Transport  
for NSW

**Notice of Exhibition - New Grafton Correctional Centre Stage 2 – Design,  
Construction and Operation (SSD 8368)**

**Attachment A:** Bus pick-up/drop-off area; further detail required.

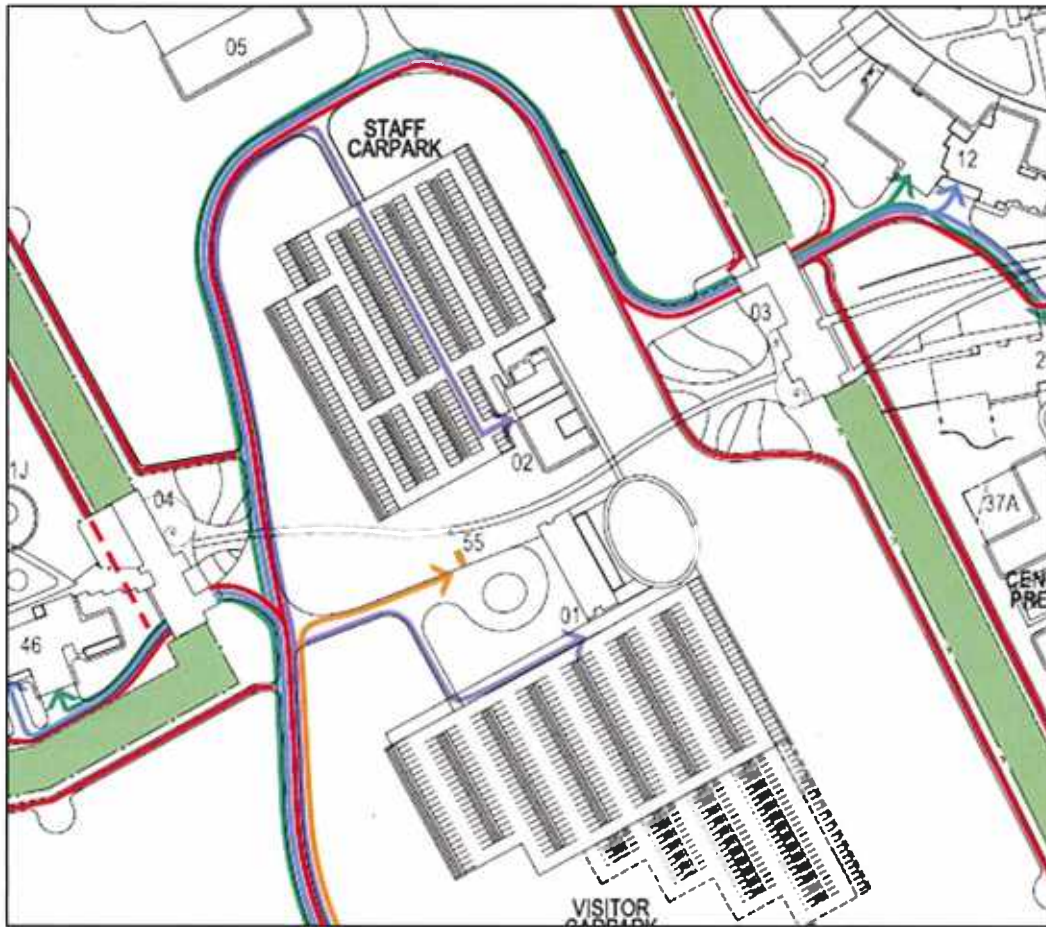
TfNSW notes that Section 3.9 of the *Transport & Accessibility Report* states that provisions will be made onsite to accommodate bus services. Whilst TfNSW understands that the access road is 'bus capable', we require further detail regarding the pick-up/drop-off area (at **Attachment A**), to ensure there is adequate swept path for the safe movement of buses within the site.
